CONSTRUCTION SUMMARY

Mountainview Heights 3 (G) - Russell Gardens Building Ltd.

LOT / PHASE	REG. PLAN #	HOUSE TYPE		
482 / 4	62M-1266	Mountainash Four (4 Bedroom) Elev 1

CONSTRUCTION SUMMARY
PRELIMINARY: DATE JUN 30 2021
FINAL: DATE

MOUNTAINASH FOUR ELEV. 1 • 3,189 sq.ft. | ELEV. 2 • 3,191 sq.ft. | ELEV. 3 • 3,196 sq.ft.

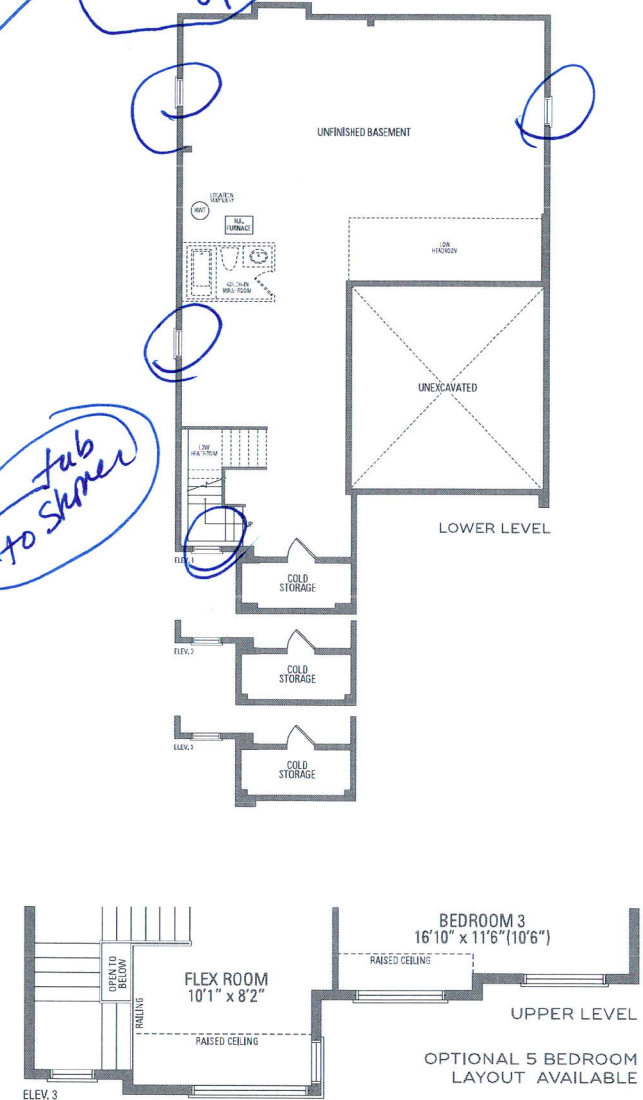
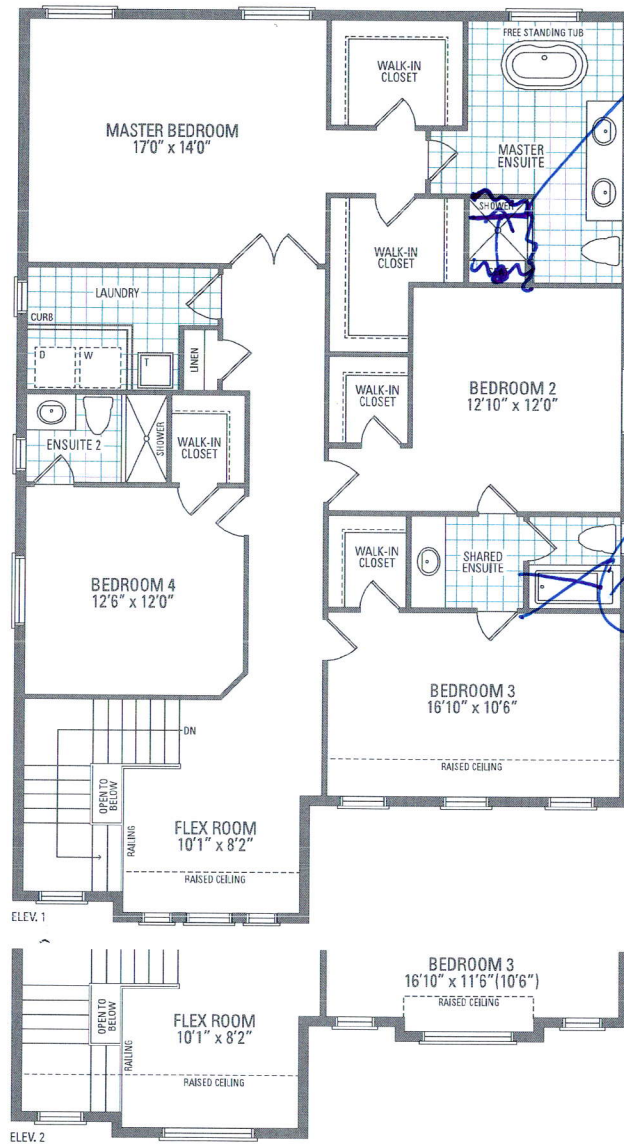
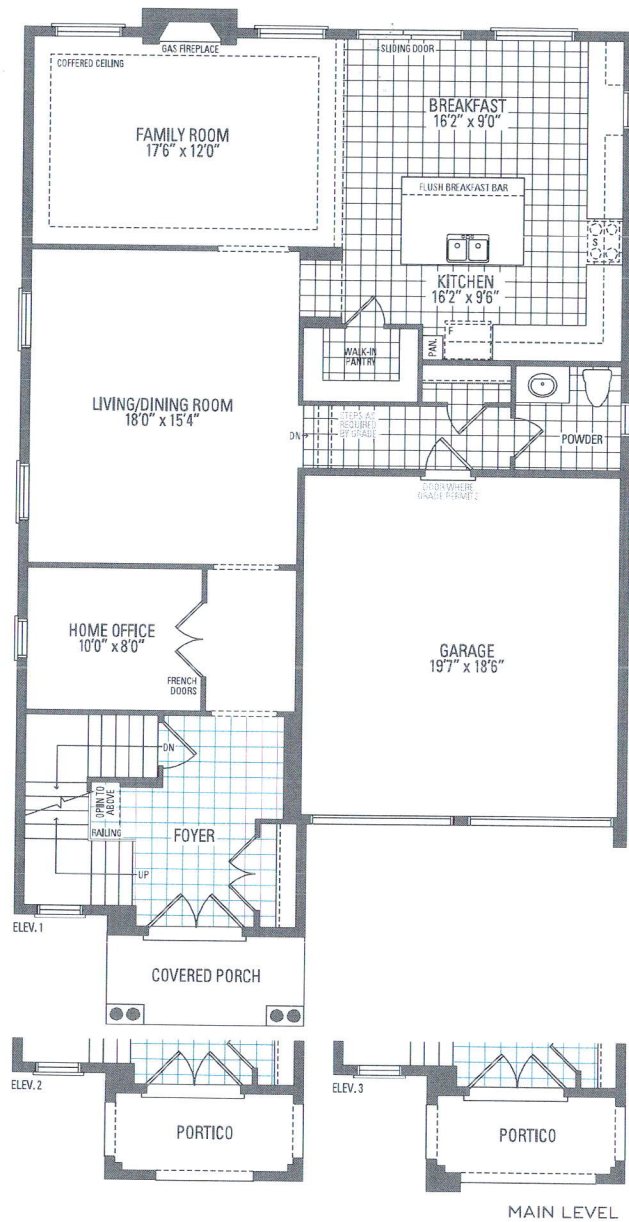
1 - MASTER ENSUITE - FRAMELESS GLASS SHOWER ENCLOSURE - INCLUDES CHROME KNOB AND HINGES 28Jun21 Note: See Sketch -	
---	--

1 - WATER LINE FOR FRIDGE - ROUGH-IN ONLY 28Jun21 Note:	
1 - 5 FOOT SHOWER WITH SLIDING GLASS CHROME DOORS IN LIEU OF TUB 28Jun21 Note: ENSUITE 2/3.

*Handers
Glass Enclosure
Switch seat
opposite side*

*Tub
to Shower*
